**ADDENDUM
NO. 4**

**Alexandria Athletic Field Improvements
1 Burden Court
Alexandria, IN 46001**

Addendum Four (AD.04) to the drawings and specifications prepared by Gibraltar Design for **Alexandria High School Athletic Field Improvements** for Alexandria Community School Corporation, Alexandria, Indiana.

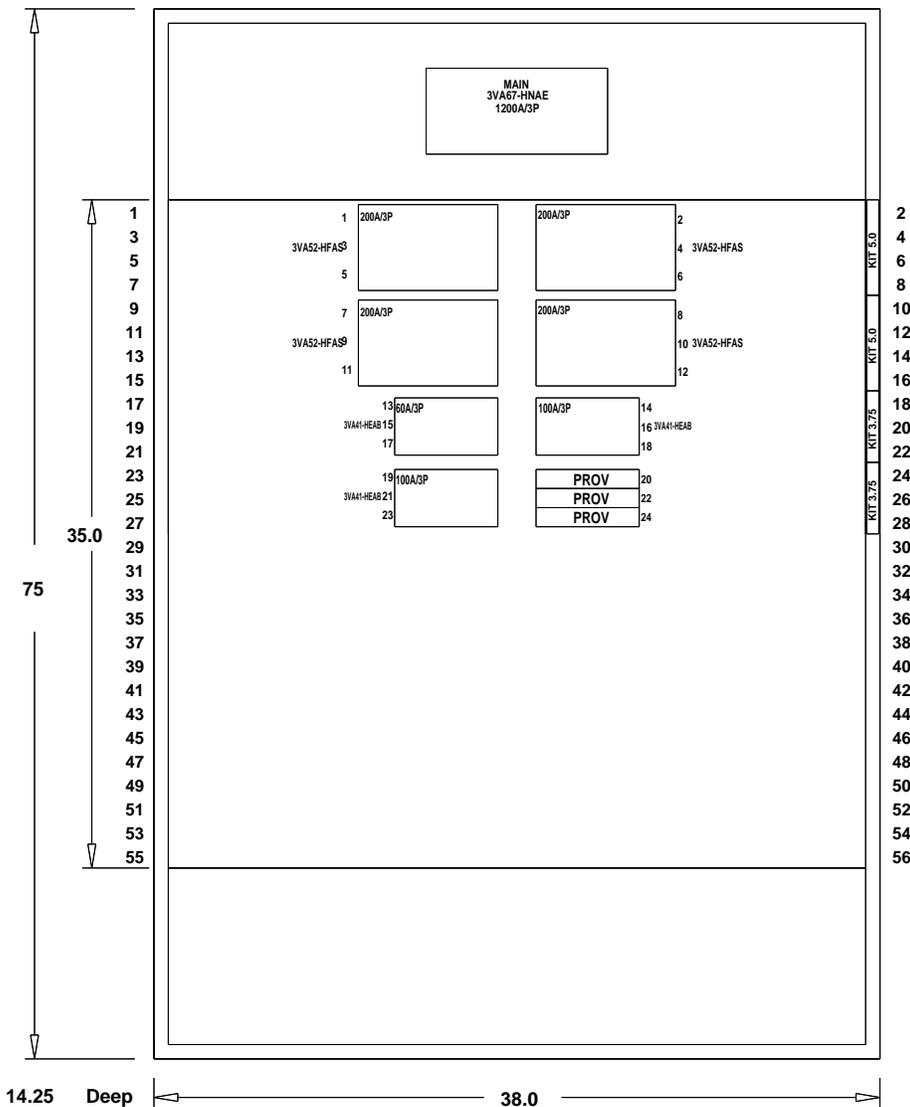
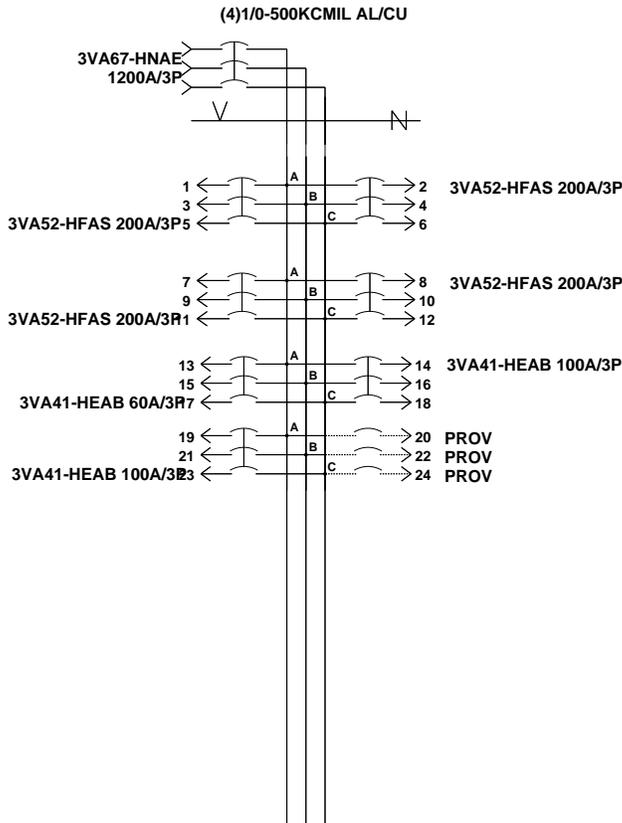
- C. Alternate panel 1200a main breaker lugs only accept 500 MCM. 200-amp feed breakers will not accept 4/0 wire.
 1. We got confirmation from Siemens that their Main Distribution Panelboard in a NEMA 1 enclosure would accept the 600 MCM conductors but their Main Distribution Panelboard in NEMA 4X enclosure will not accept the 600 MCM conductors. Therefore, we will revise the feeders for the new incoming electrical service to the New Main Distribution Panel "FBMDP" - Alternate Bid shown on Drawing E-701 to show four (4) sets of 3 1/2"C, 4-#400 MCM (CU) in each.

2. Siemens also confirmed that their Main Distribution Panel 200 Amp Circuit Breakers will accept the #4/0 conductors.

3. See a set of preliminary layout drawings of the Main Distribution Panel from Siemens that was used a basis of design and included for reference purposes only.
